**Re: Bob's Burgers, West Central/46th Street, Grading and Drainage Plan
Engineer's Stamp dated 11-06-2013 (K-12/D032)**

**BOB'S BURGERS
W. CENTRAL
&
46TH STREET**

GRADING PLAN

**Re: Bob's Burgers, West Central/46th Street, Grading and Drainage Plan
Engineer's Stamp dated 07-30-2013 (K-12/D032)**

From: Rodriguez, Jason T.
Sent: Friday, September 26, 2014 2:43 PM
To: Cherne, Curtis
Cc: Harmon Rita T.
Subject: Bob's Burgers SO-19
Attachments: DSCN1191.JPG

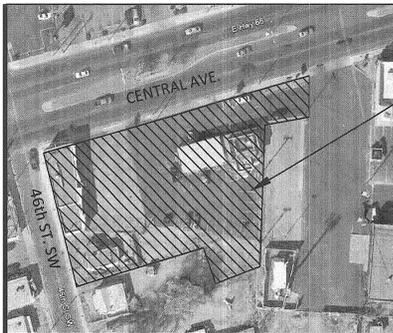
Hi Curtis I was out today at 46th and Central SW They have completed the pond at the corner and the pipes on face of curb are acceptable as for the sidewalk culvert the only thing is for the bolts to be tack welded I talked with TLC and John said he would have it done so it's a pass. The pond at the culvert was still under construction to include half of the landscaping. Let me know if you need any more.

GRADING AND DRAINAGE PLAN

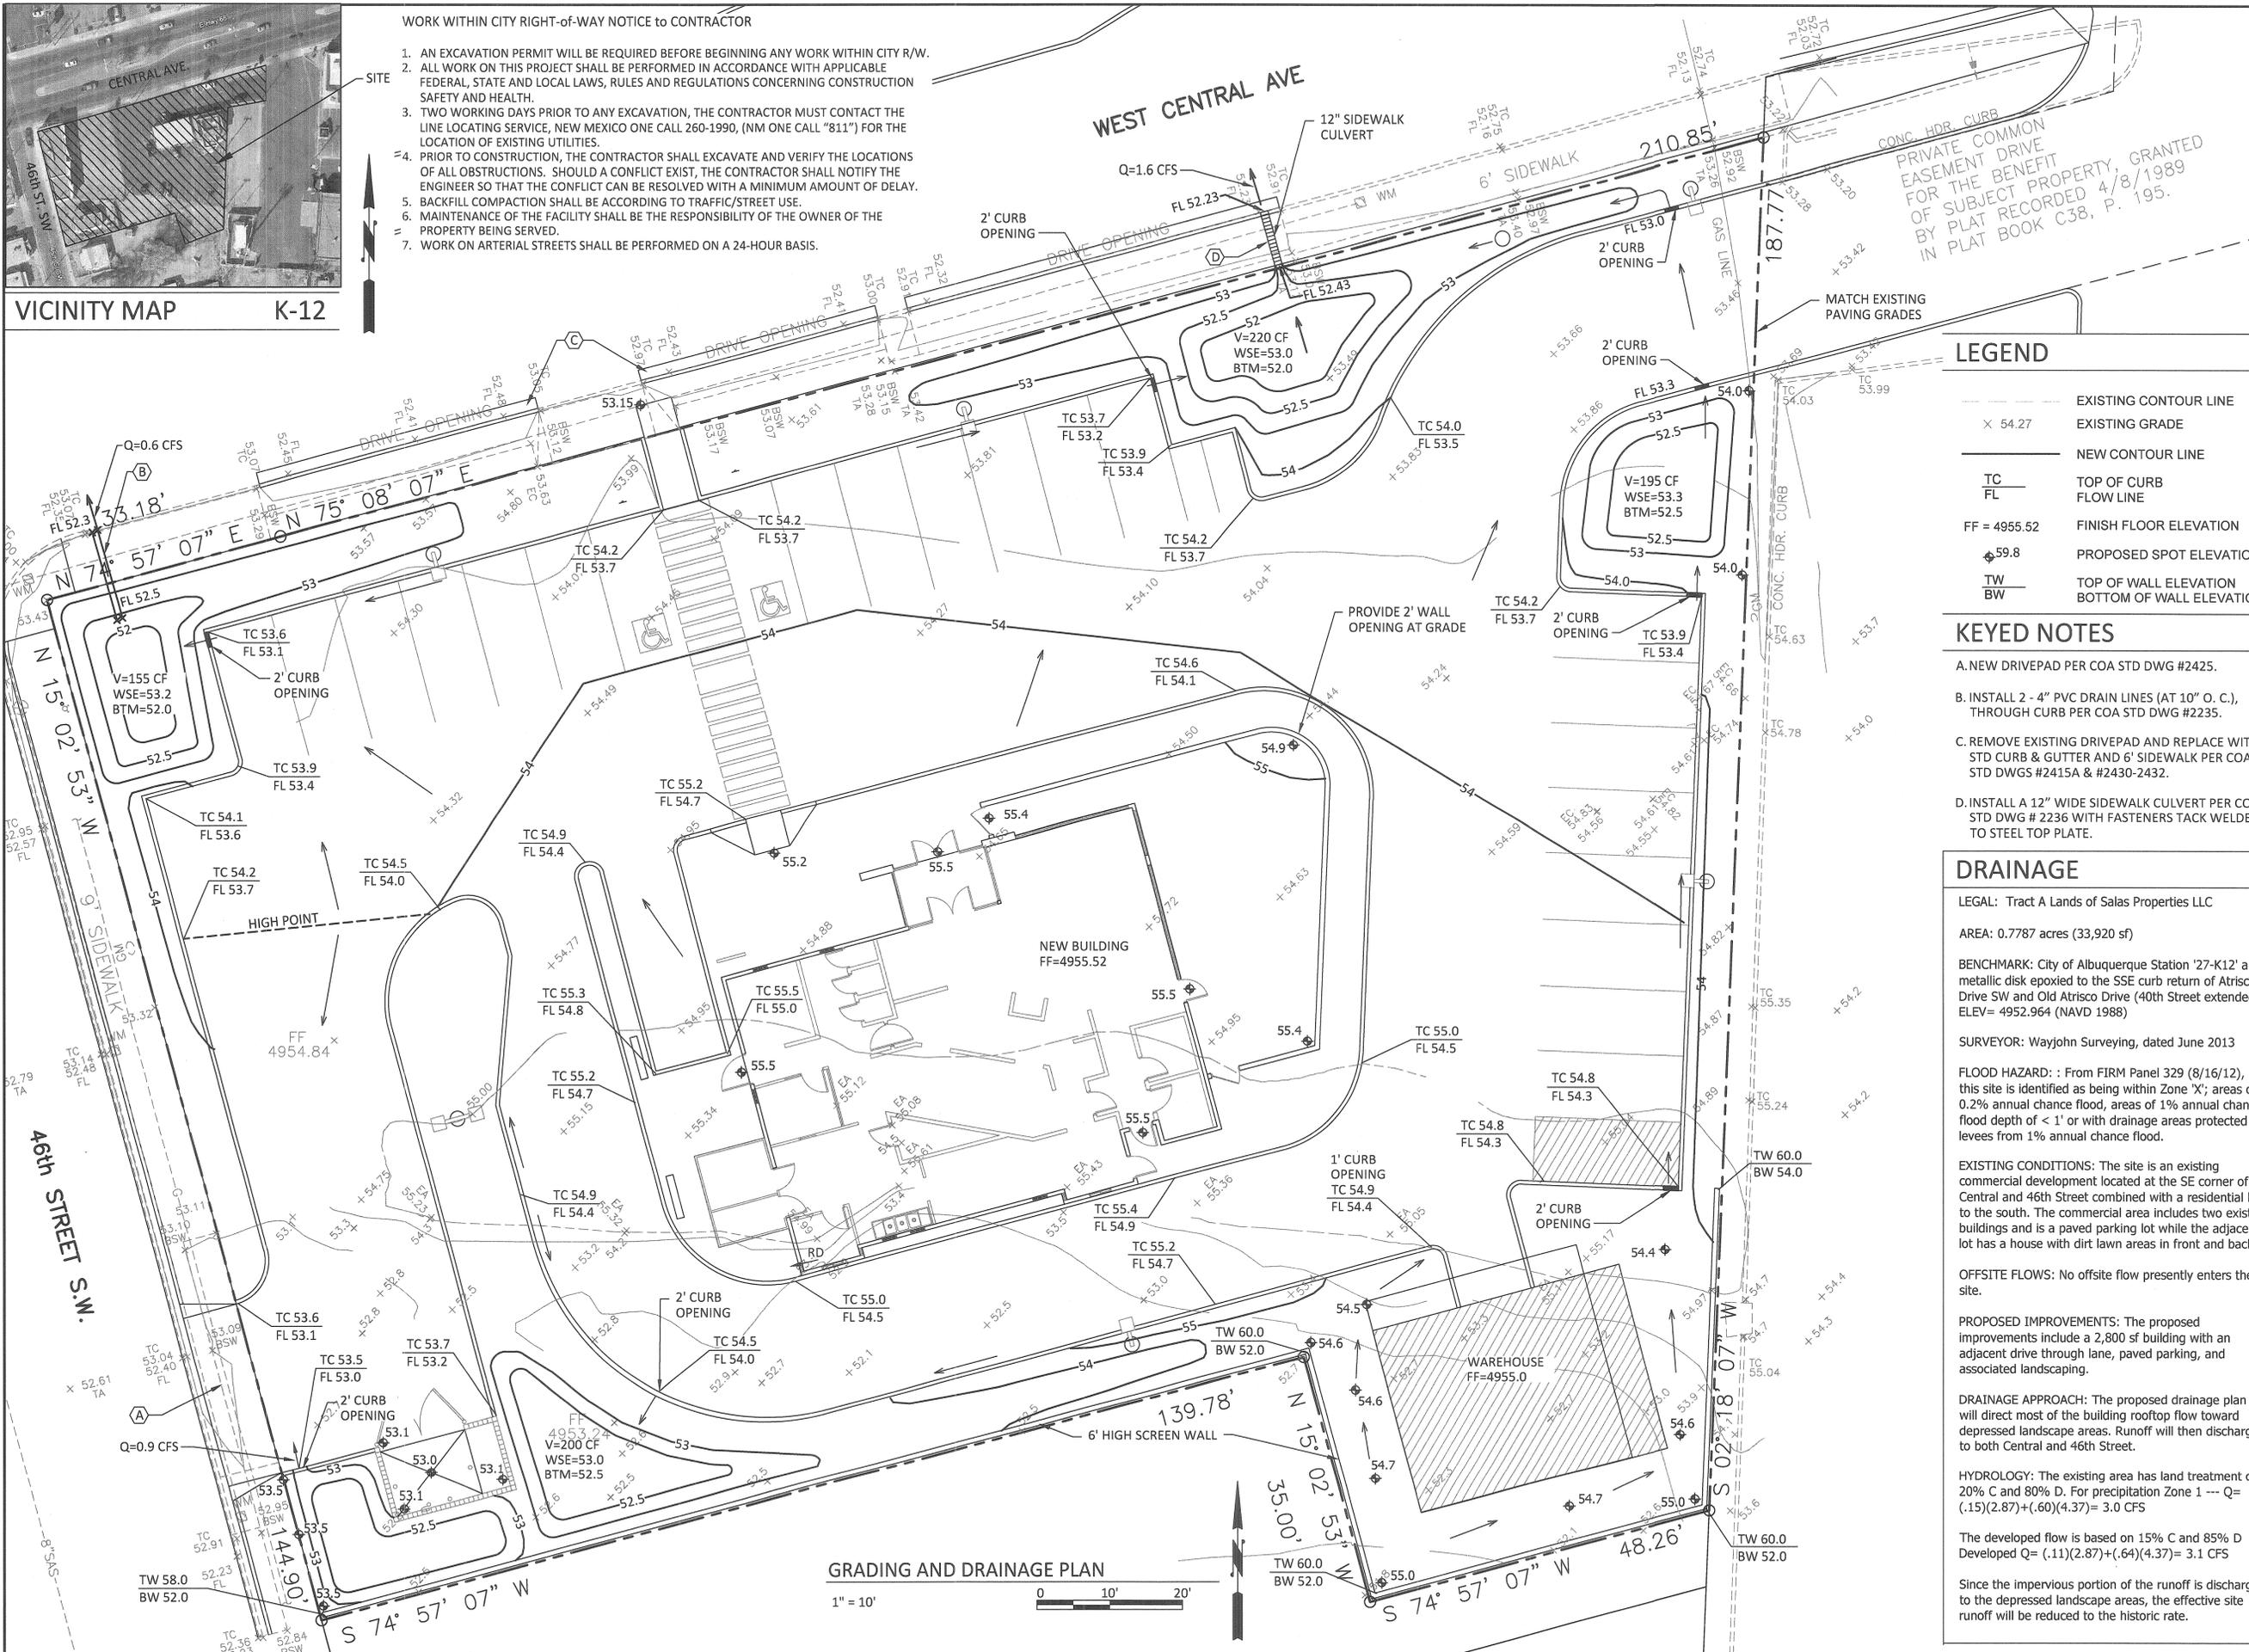
- Both proposed curb penetrations need to reference City Standard Drawing #2235. The SO-19 standard notes need to be added to the grading plan.
- Raise the grades south side of the warehouse to create positive flow to the front.

- Provide additional spot elevations along at the sidewalk connection for the ADA path.
- Provide pond calculations for each of the proposed water harvesting ponds.

- Provide top-of-pond and bottom-of-pond elevations for the ponds along with flow calculations and capacity for the two pipe penetrations along Central Ave. Runoff will not be allowed to drain over the sidewalk.

- Are the sidewalks on the plan proposed or existing?
- The trash enclosure will need to show a drain connection to the sanitary sewer system. Provide additional spot elevations at the corners of the enclosure.

- The driveways which are not being used should be removed and new curb and gutter and sidewalk should be constructed.

- A. NEW DRIVEPAD PER COA STD DWG #2425.
- B. INSTALL 2 - 4" PVC DRAIN LINES (AT 10" O. C.), THROUGH CURB PER COA STD DWG #2235.
- C. REMOVE EXISTING DRIVEPAD AND REPLACE WITH STD CURB & GUTTER AND 6' SIDEWALK PER COA STD DWGS #2415A & #2430-2432.
- D. INSTALL A 12" WIDE SIDEWALK CULVERT PER COA STD DWG # 2236 WITH FASTENERS TACK WELDED TO STEEL TOP PLATE.
